Line 28 Transmission Project

Case 10-T-0283

Environmental Management and Construction Plan Supplement

Revised November 29, 2010

Figure 2.7-1

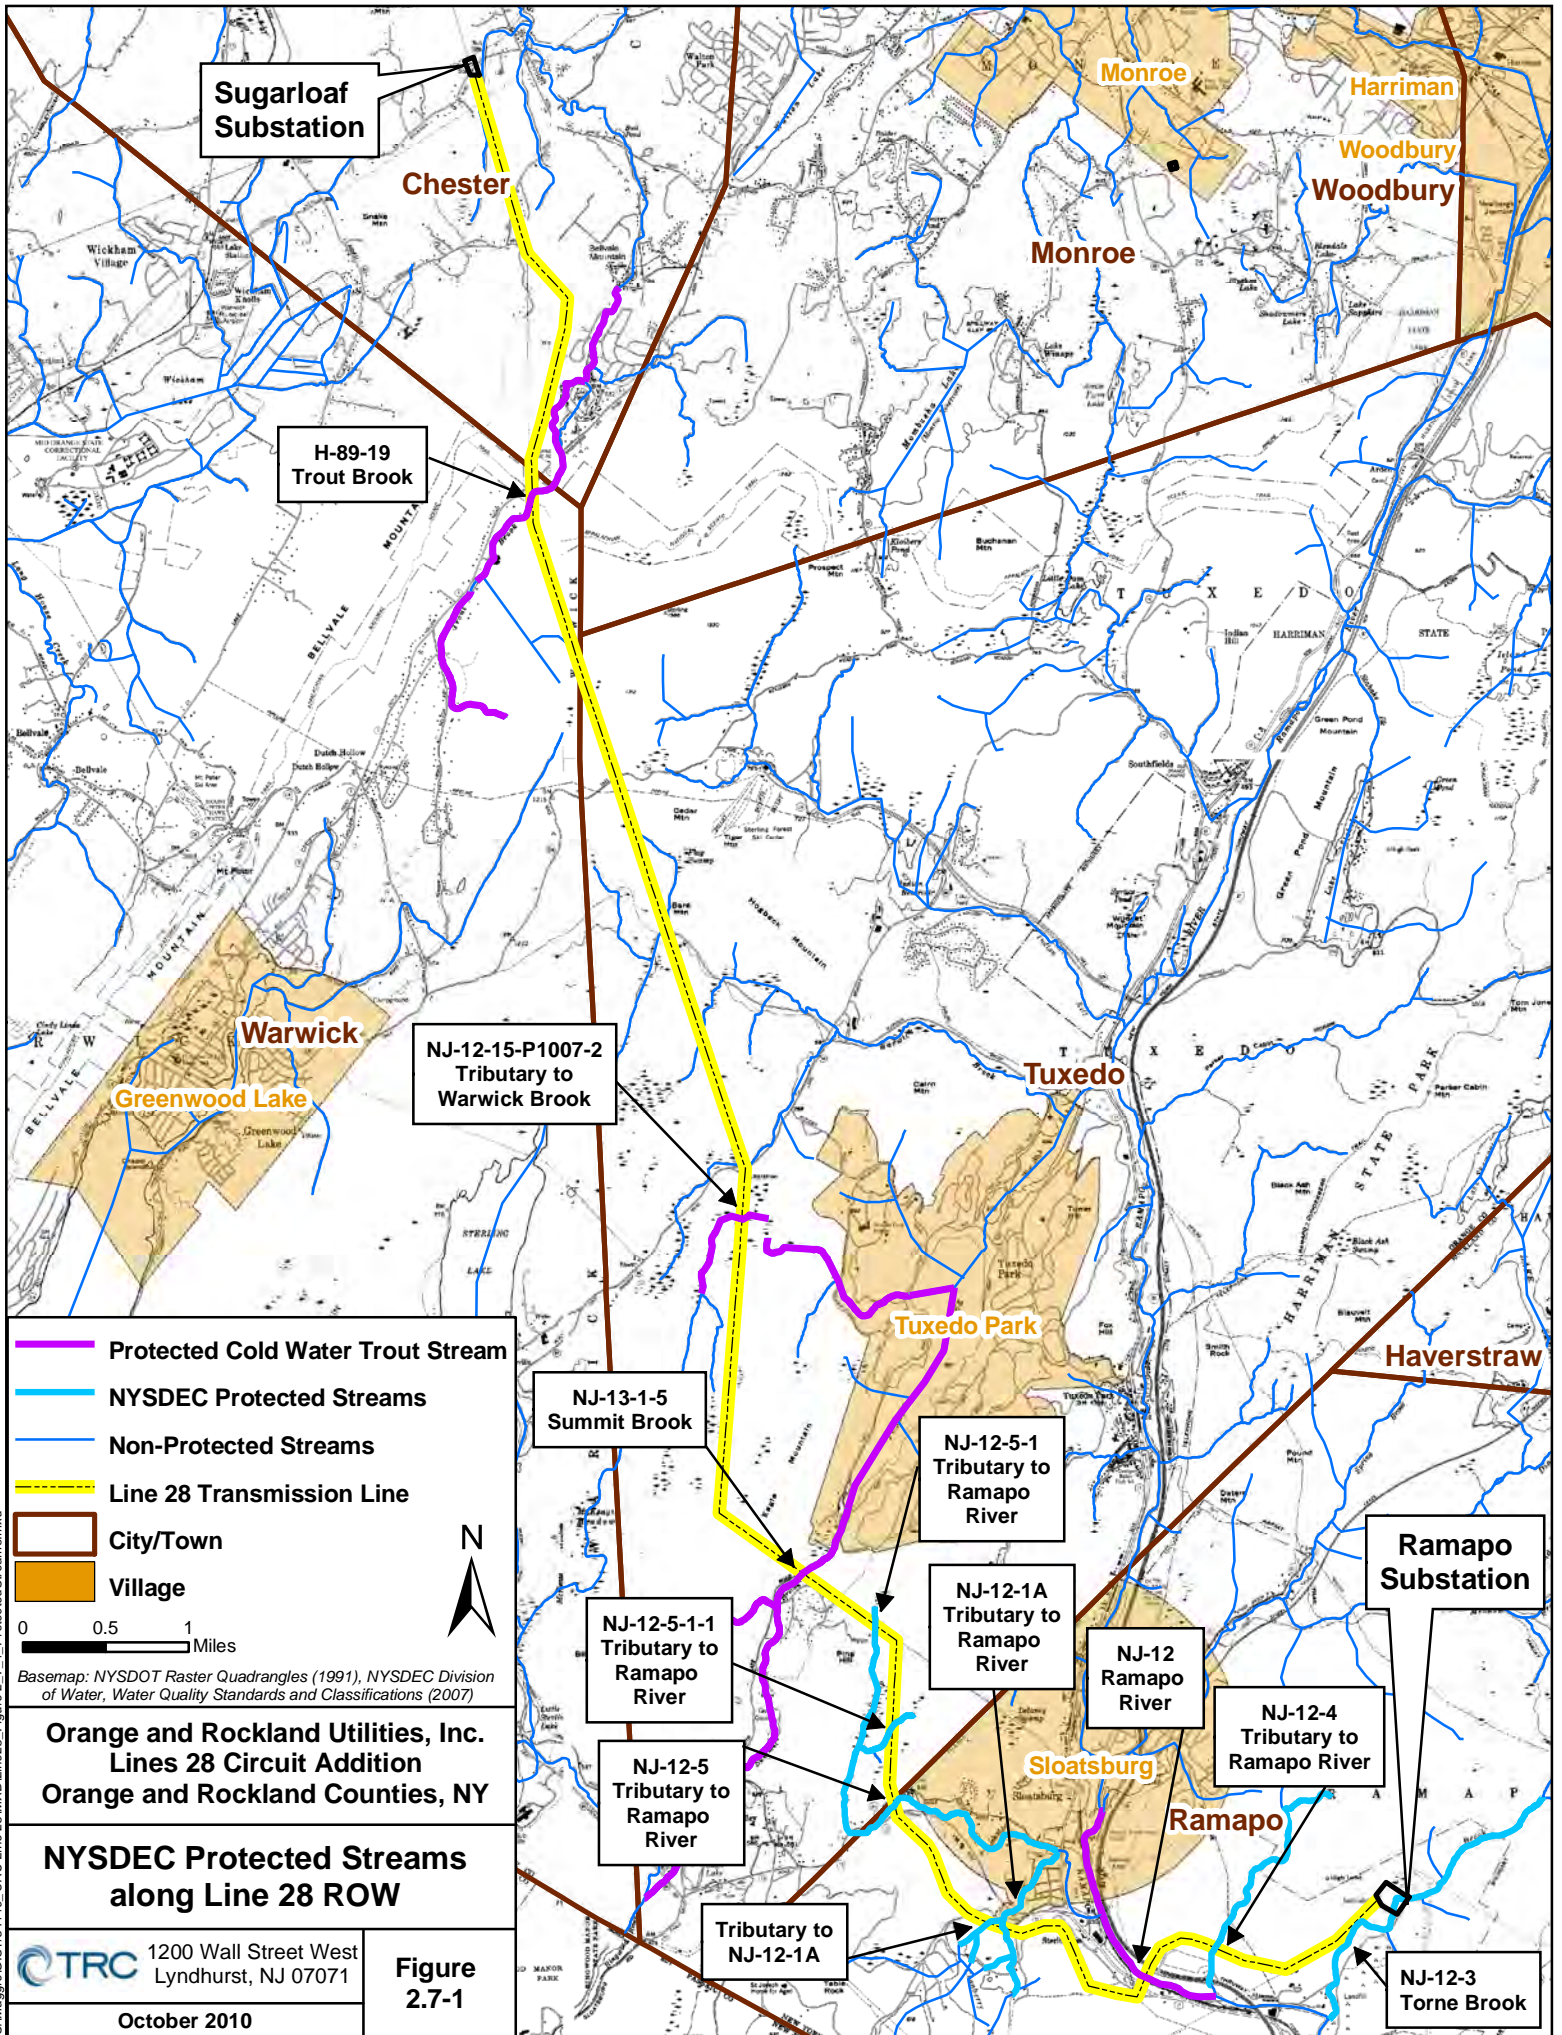
Comment NYSDEC-5:

Comment noted. NYSDEC wetlands crossed by the Line 28/Line 77 transmission ROW are illustrated on EM&CP Figure 3.4-20 and the detailed project aerials provided as Figures 3.4-1 through 3.4-19 of the EM&CP.

Figure 2.7-1 included on the following page, provides the locations of the above-referenced streams and tributaries and Line 28/Line 77 ROW. Information regarding the required crossing activity at these locations is provided below.

The protected streams, which are anticipated to require vehicular crossing during construction in order to gain access to the structure locations, include the Trout Brook and the Tributary to Warwick Brook (see Figure 2.7-1). The Trout Brook is Classified as a C(t) stream and the Tributary to Warwick Brook is classified as a Class AA(t) stream. Both streams are considered part of a cold water fishery and therefore, consistent with ORU's general permit, construction will be prohibited from October 1 through May 31. To support the installation of Line 28, it is anticipated that a temporary culvert will be placed within the streams to provide a stream crossing for vehicles and maintaining stream integrity. The temporary crossing of ditch/stream method illustrated on the soil erosion and sediment control detail sheet provided in Attachment 1 of the EM&CP will be utilized to cross the streams (see drawing no. 8865, "Line 28/77 – 138kV Ramapo Substation to Sugarloaf Substation Erosion Control Details"). This temporary crossing method consists of a culvert being placed into the stream to maintain flow. The stream bed and bank will first be layered with filter fabric, with the culvert laid over the fabric. The area will then be covered with clean gravel to form a road. Both banks of the stream on either side of the road will then be stabilized with hay bales. Upon completion of construction, the temporary crossing will be removed and the stream will be restored to pre-construction conditions. Restoration efforts will include grading, mulching and seeding as necessary.
